Site Accessibility Evaluation

James Park

1213 High Meadow Dr

Evaluation Date: 12/16/2021

Barrier: 1

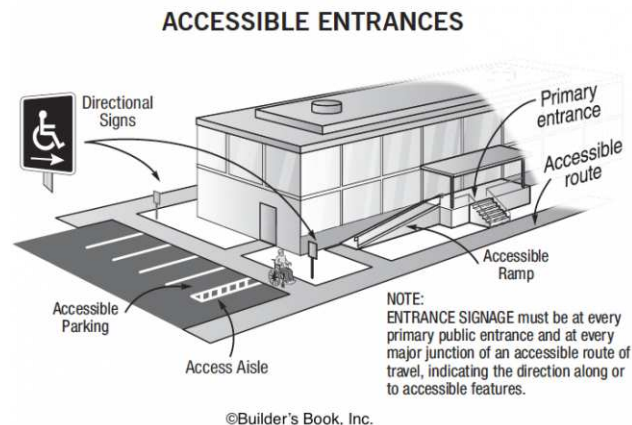
There is no accessible route of travel from the public way. At least one accessible route shall be provided within the site from accessible parking spaces and accessible passenger loading zones; public streets and sidewalks; and public transportation stops to the accessible building or facility they serve.

There is no accessible route
of travel from the public way
to the park.

Provide an accessible route of travel from the public way to the park path of travel.

Barrier: 2

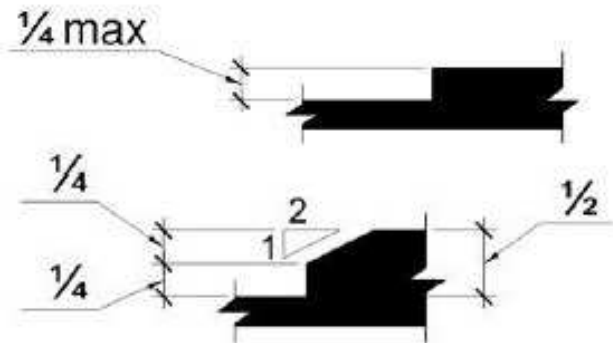
The walkway contains abrupt vertical edges and/or variations over 1/4 inch when 1/4 inch is the maximum vertical rise. Changes in level between 1/4 inch and 1/2 inch must be beveled at 1:2 or less. Changes in level greater than 1/2 inch must be by way of a ramp.

The path of travel contains
abrupt vertical edges
measuring 1 inch.

Modify the path of travel to provide a smooth level surface.

Barrier: 3

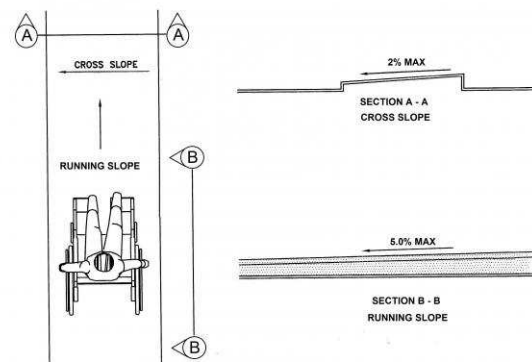
The accessible path of travel has cross slopes greater than 2 percent.

The accessible route of travel contains a cross slope of 2.6 percent.

Modify path of travel to achieve a cross slope that is no greater than 1:48 (2.08 percent).

Barrier: 4

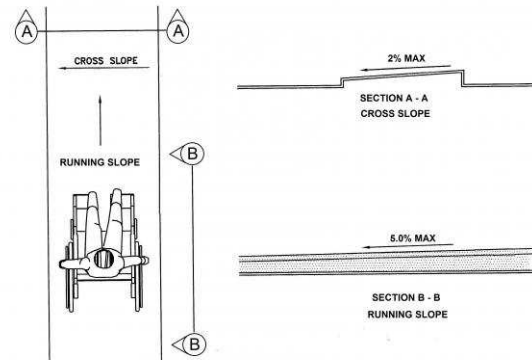
The accessible path of travel has cross slopes greater than 2 percent.

The accessible route of travel contains a cross slope of 4.2 percent.

Modify path of travel to achieve a cross slope that is no greater than 1:48 (2.08 percent).

Barrier: 5

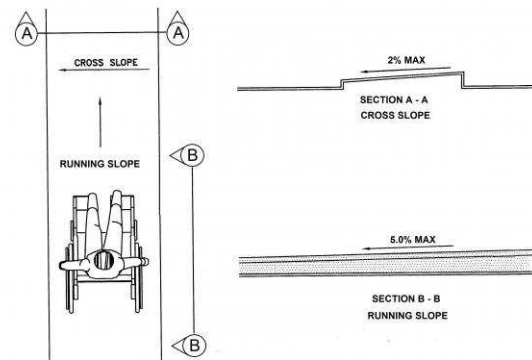
The accessible path of travel has cross slopes greater than 2 percent and changes in level.

The accessible route of travel contains a cross slope of 6.1 percent and changes in level.

Modify path of travel to achieve a cross slope that is no greater than 1:48 (2.08 percent) and eliminate changes in level.

Barrier: 6

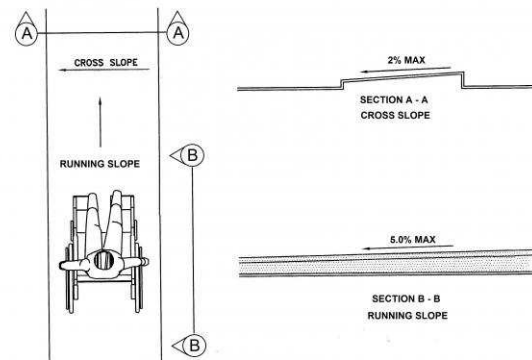
The accessible path of travel has cross slopes greater than 2 percent and changes in level.

The accessible route of travel contains a cross slope of 7.3 percent and changes in level.

Modify path of travel to achieve a cross slope that is no greater than 1:48 (2.08 percent) and eliminate changes in level.

Barrier: 7

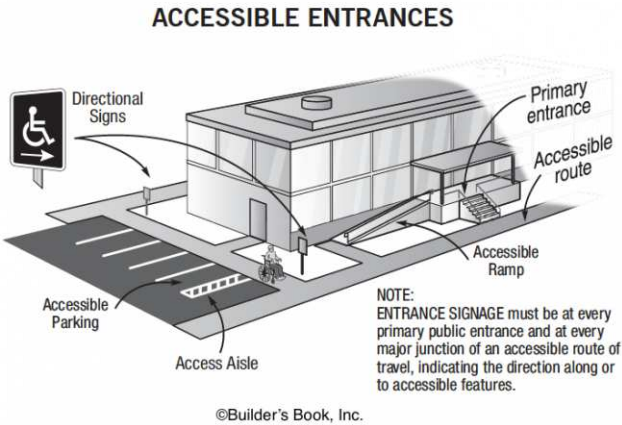
There is no accessible route to the trash cans. At least one accessible route shall connect accessible buildings, accessible facilities, accessible elements, and accessible spaces that are on the same site.

Citation:	Current Condition:	Budget Cost:
2010 ADAS Section: 206.2.2	There is no accessible route to the trash cans.	Base Cost: \$1,500.00
1991 ADAAG Section: 4.1.2(1)		Contingency Cost: \$300.00
		Design Cost: \$200.00
		Total Cost: \$2,000.00

Relocate the trash cans closer to the path of travel or provide an accessible route of travel to the trash cans.

Barrier: 8

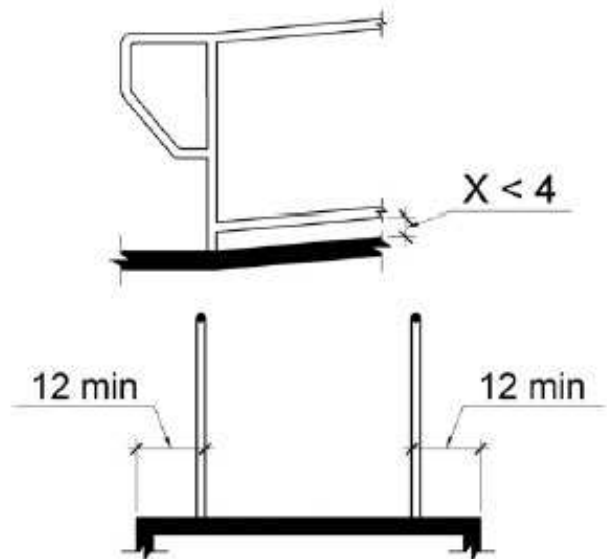
The required edge protection is missing. The floor or ground surface shall extend 12 inches minimum beyond the inside face of a handrail or a curb or barrier shall be provided that prevents the passage of a 4 inch diameter sphere, where any portion of the sphere is within 4 inches of the finish floor or ground surface.

The path of travel has a drop-off greater than 6 inches and edge protection has not been provided.

Provide edge protection at the areas containing drop-offs along the path of travel.

Barrier: 9

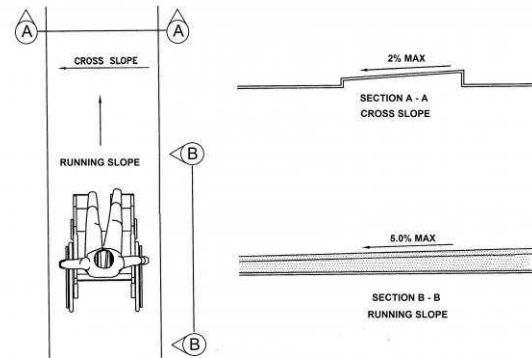
The accessible path of travel has cross slopes greater than 2 percent.

The accessible route of travel contains a cross slope of 4.2 percent.

Modify path of travel to achieve a cross slope that is no greater than 1:48 (2.08 percent).

Barrier: 10

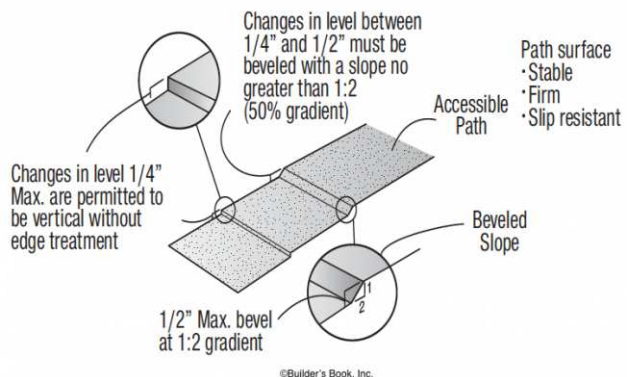
The accessible route contains surface materials that do not provide for a stable, firm, slip-resistant surface.

The accessible route of travel contains leaves and dirt build-up that is not stable, firm, or slip-resistant.

Modify the accessible route of travel to eliminate the collection of leaves and dirt build-up.

Barrier: 11

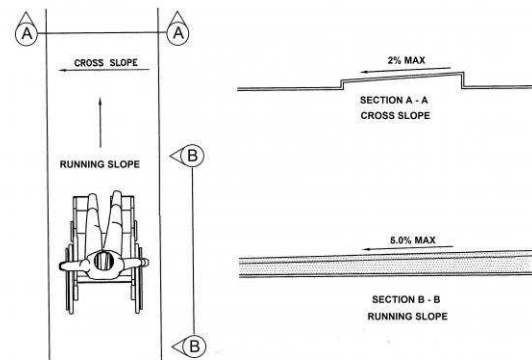
The accessible path of travel has cross slopes greater than 2 percent.

The accessible route of travel contains a cross slope of 7.4 percent.

Modify path of travel to achieve a cross slope that is no greater than 1:48 (2.08 percent).

Barrier: 12

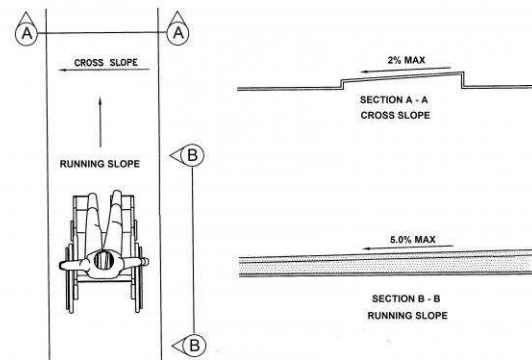
The accessible path of travel has cross slopes greater than 2 percent and changes in level.

The accessible route of travel contains a cross slope of 10.6 percent and changes in level.

Modify path of travel to achieve a cross slope that is no greater than 1:48 (2.08 percent) and eliminate changes in level.

Barrier: 13

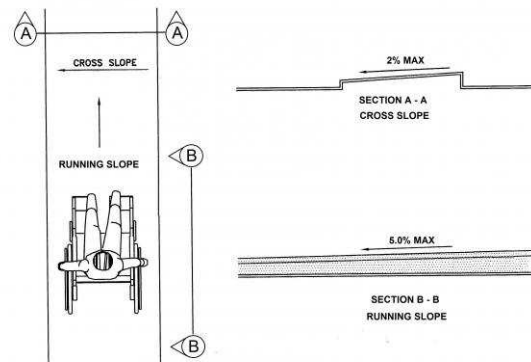
The accessible path of travel has cross slopes greater than 2 percent and changes in level.

The accessible route of travel contains a cross slope of 4.2 percent and changes in level.

Modify path of travel to achieve a cross slope that is no greater than 1:48 (2.08 percent) and eliminate changes in level.

Barrier: 14

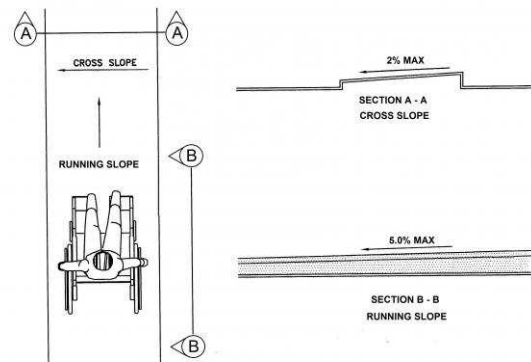
The accessible path of travel has cross slopes greater than 2 percent and changes in level.

The accessible route of travel contains a cross slope of 2.4 percent and changes in level.

Modify path of travel to achieve a cross slope that is no greater than 1:48 (2.08 percent) and eliminate changes in level.

Barrier: 15

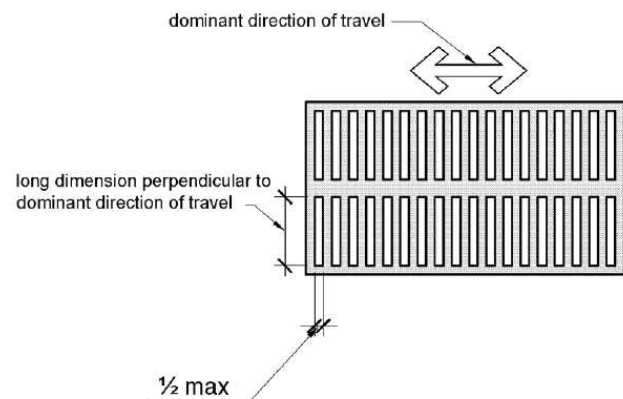
The concrete expansion joints are spaced greater than 1/2 inch. Openings in ground surfaces shall not allow passage of a sphere more than 1/2 inch diameter.

The concrete expansion joints are spaced greater than 1/2 inch.

Fill the expansion joints to alleviate gap.

Barrier: 16

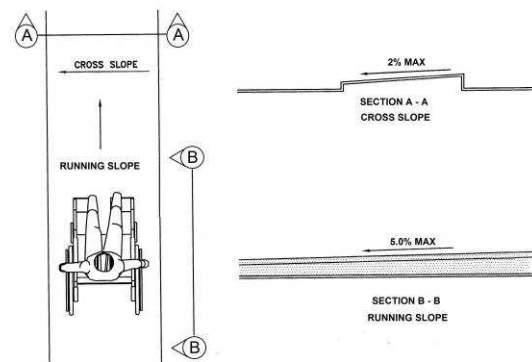
The accessible path of travel has cross slopes greater than 2 percent and abrupt changes in level.

The accessible route of travel contains a cross slope of 5.2 percent and abrupt changes in level.

Modify path of travel to achieve a cross slope that is no greater than 1:48 (2.08 percent) and eliminate changes in level.

Barrier: 17

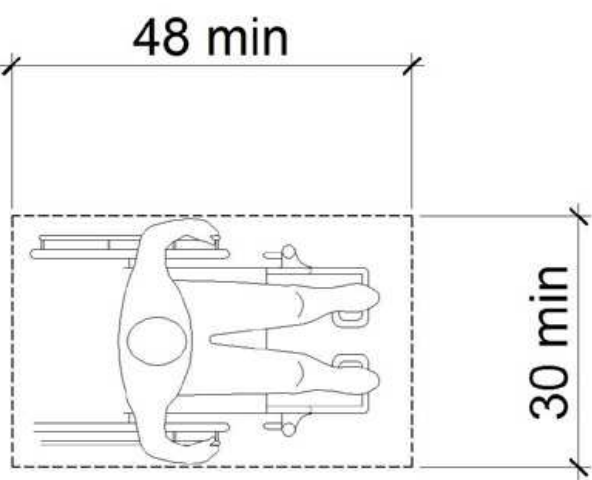
The clear floor space required at the trash cans is not flat (2 percent or 1:48 maximum slope) in all directions. Changes in level are not permitted at required clear floor or ground space except that slopes not steeper than 1:48 shall be permitted.

Citation:	Current Condition:	Budget Cost:
2010 ADAS Section: 305.2	The clear floor space required at the trash cans	Base Cost: \$1,500.00
1991 ADAAG Section: 4.2.4.1	contains a 3.2 percent slope.	Contingency Cost: \$300.00
		Design Cost: \$200.00
		Total Cost: \$2,000.00

Modify the clear floor space at the trash cans to provide a slope no greater than 2 percent in any direction.

Barrier: 19

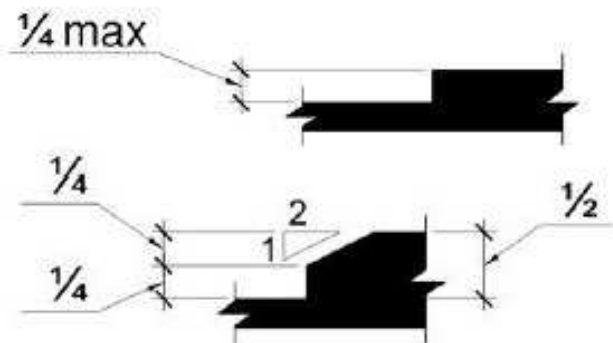
The walkway contains abrupt vertical edges and/or variations over 1/4 inch where 1/4 inch is the maximum vertical rise. Changes in level between 1/4 inch and 1/2 inch must be beveled at 1:2 or less.

The walkway contains
abrupt vertical edges and/or
variations over 1/4 inch.

Modify the path of travel to provide a smooth level surface.

Barrier: 20

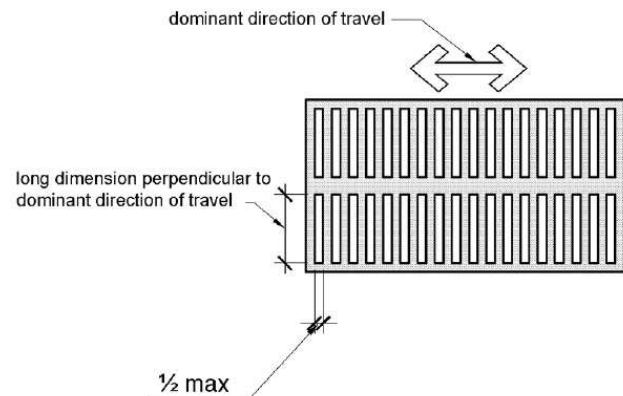
The concrete expansion joint is spaced greater than 1/2 inch. Openings in floor or ground surfaces shall not allow passage of a sphere more than 1/2 inch diameter. Elongated openings shall be placed so that the long dimension is perpendicular to the dominant direction of travel.

The entire area around the tree contains a concrete expansion joint spaced greater than 1/2 inch.

Fill the expansion joint in the entire area around the tree to alleviate gaps.

Barrier: 21

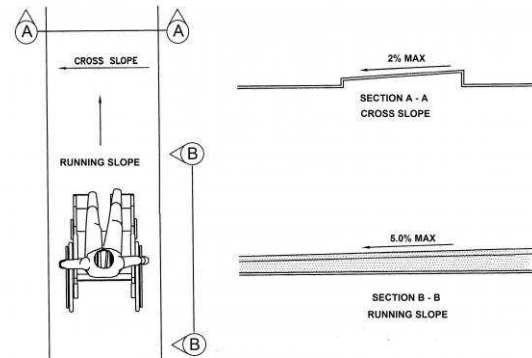
The accessible path of travel has cross slopes greater than 2 percent.

The accessible route of travel contains a cross slope of 3.6 percent.

Modify path of travel to achieve a cross slope that is no greater than 1:48 (2.08 percent).

Barrier: 22

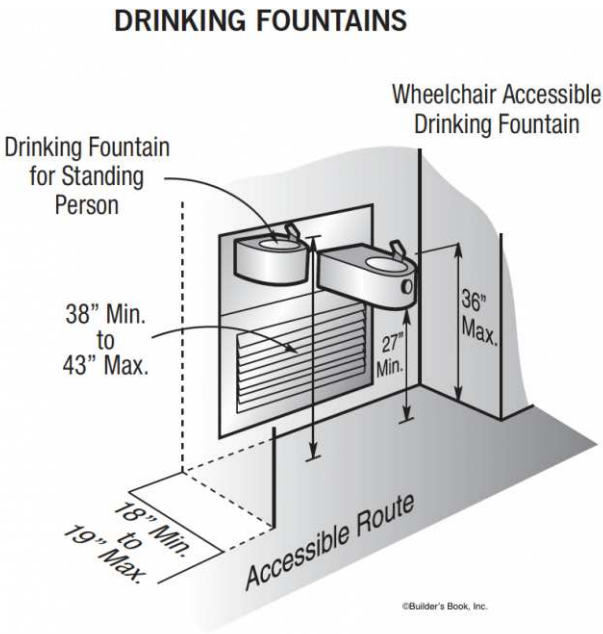
The drinking fountain has multiple violations.
Drinking fountains must be on an accessible route that provides a 30 inch by 48 inch clear floor space centered on the low unit, allowing a forward approach. The spout shall provide a flow of water 4 inches high minimum and shall be located 5 inches maximum from the front of the unit.

Citation:	Current Condition:	Budget Cost:
2010 ADAS Section: 403.5.1, 602.1	The drinking fountain has multiple violations and was not operational at time of evaluation.	Base Cost: \$2,500.00 Contingency Cost: \$500.00 Design Cost: \$400.00 Total Cost: \$3,400.00
1991 ADAAG Section: 4.15.1

Possible Solutions:
Modify the area at the water fountain to provide the required clear floor space with slopes no greater than 2 percent in any direction, and adjust the water flow to provide a minimum of 4 inches.

Barrier: 23

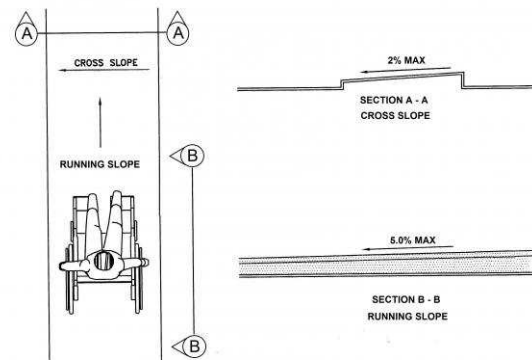
The accessible path of travel has cross slopes greater than 2 percent and abrupt changes in level.

The accessible route of travel contains a cross slope of 3.1 percent and abrupt changes in level.

Modify path of travel to achieve a cross slope that is no greater than 1:48 (2.08 percent) and to eliminate changes in level.

Barrier: 24

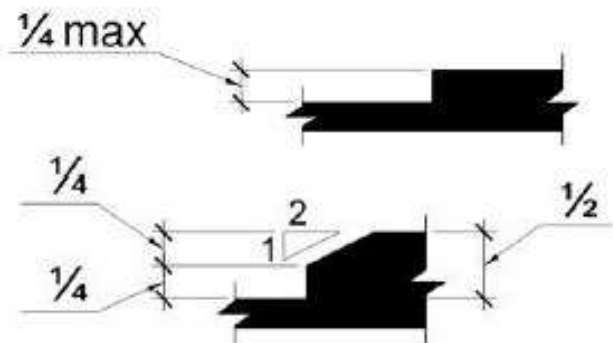
The ramp to the playground contains abrupt vertical edges and/or variations over 1/4 inch.

The ramp to the playground
contains abrupt vertical
edges and/or variations over
1/4 inch.

Modify the ramp to the playground to eliminate changes in level greater than 1/4 inch.

Barrier: 25

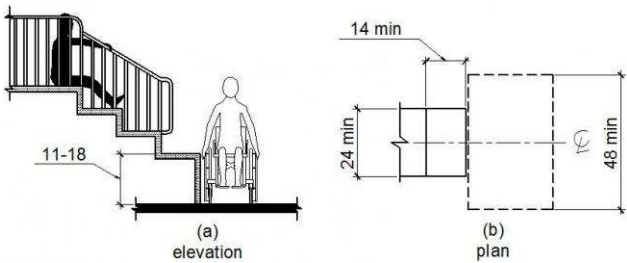
The transfer platform is not level. Transfer platforms shall have level surfaces 14 inches deep minimum and 24 inches wide minimum.

Citation:	Current Condition:	Budget Cost:
2010 ADAS Section: 1008.3.1.1	The transfer platform contains a 2.8 percent slope.	Base Cost: \$1,500.00 Contingency Cost: \$300.00 Design Cost: \$200.00 Total Cost: \$2,000.00

Possible Solutions:
Modify the transfer platform to provide a level surface.

Barrier: 26

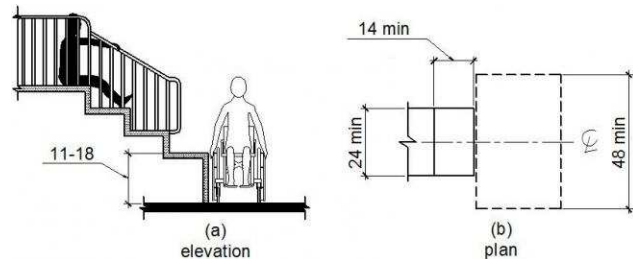
The transfer platform is not within the compliant range above the ground. The height of transfer platforms shall be 11 inches minimum and 18 inches maximum measured to the top of the surface from the ground or floor surface.

The transfer platform is not within the compliant range above the ground at 20-3/4 inches.

Modify the transfer platform so it is between 11 inches to 18 inches above the ground.

Barrier: 27

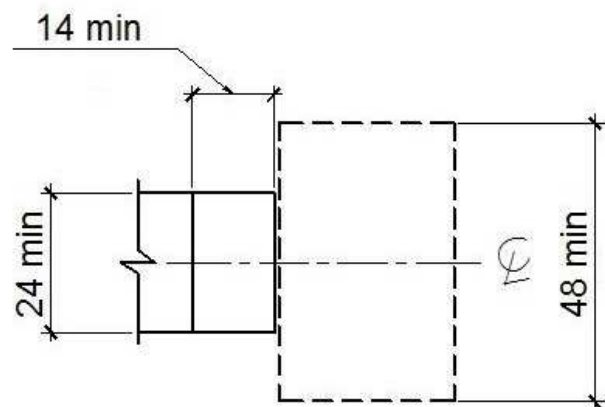
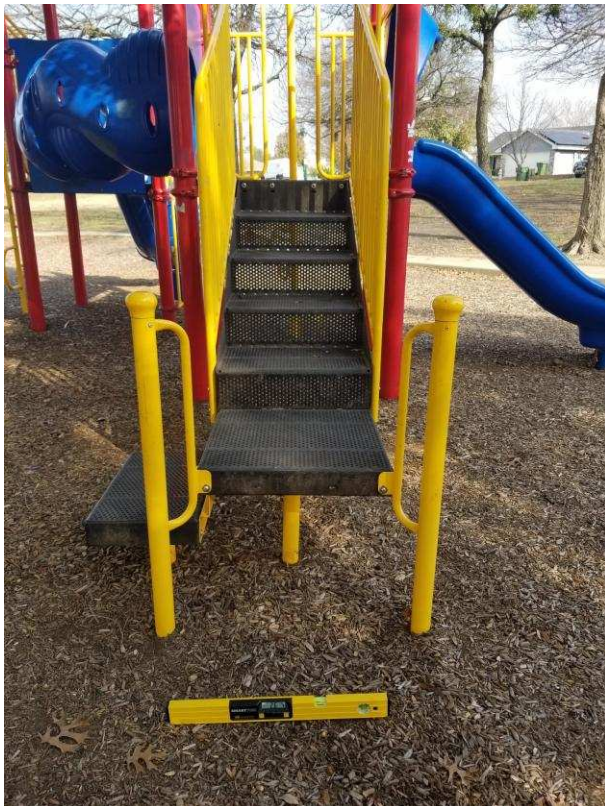
The transfer space is sloped greater than 2 percent. Clear floor shall not have changes in level or slopes steeper than 1:48.

The clear floor space at the transfer platform contains a 2.6 percent slope.

Modify the clear floor space at the transfer platform to provide a slope no greater than 2 percent in any direction.
